RotorSport UK Ltd Service Bulletin (Permit)

Title: Upgrade Cavalon to 560kg MTOW		
SB No.: 084 Iss2	Related documents MC No: MC-281 CCAR No.: None	Compliance Category:
Applicability		OPTIONAL or RECOMMENDED or MANDATORY
Aircraft type & model: Cavalon (Permit-to-Fly)	Aircraft serial Nos. affected: Any	
This form is the response from RotorSport UK Ltd either against a problem found in the product in service requiring a containment or rectification action, or as service information for aircraft modification incorporation. For help, contact RotorSport on 44(0)1588 650769, or email info@rotorsport.org.		
<u>Reason and overview of the Service Bulletin (cause of problem if known)</u>		
During development of the Cavalon Pro “certified” gyroplane the take-off weight was increased from 500kg to 560kg. A modification package has now been introduced and by embodiment of this SB-084 “Permit-to-Fly” variants of the Cavalon may also be increased to 560kg MTOW NB: This service bulletin may only be embodied if the aircraft has a 914UL or 914F turbocharged engine and is fitted with heavy-duty mainwheel tyres approved by RSUK (viz: Heidenau or Sava)

Supplementary instructions for Mk1 body moulding

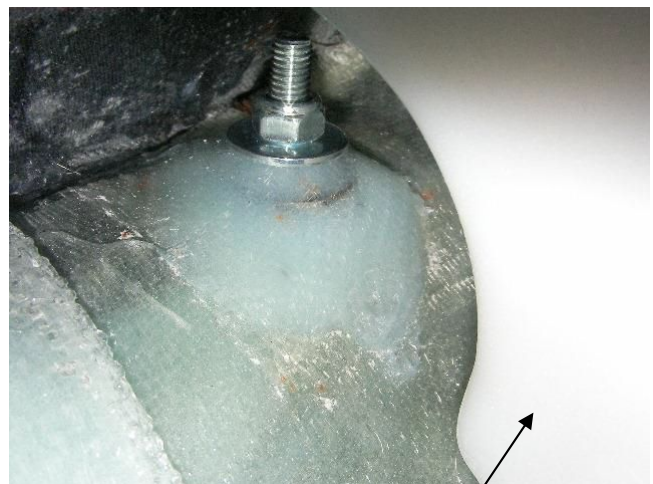
If the upgrade is being applied to a Mk1 body moulding (recognisable by the slide-bolt door locks) the forward bolts must be removed and the mounting holes drilled-through 10mm diameter to enable M10 x 100 cap-screws to be fitted. As the fuel-tanks are located close-by the fastener position the drilling depth must be mechanically limited to avoid the tank being damaged. This may be accomplished by an appropriate length drill-bit or by use of loose washers around the drill shank. For the drilling operation use a high rpm and slow feed rate

Drill and fit the screws (and large washers) one at a time to avoid the suspension bow moving during the operation. Use Loctite 243 on the new nyloc nuts and tighten to 25Nm
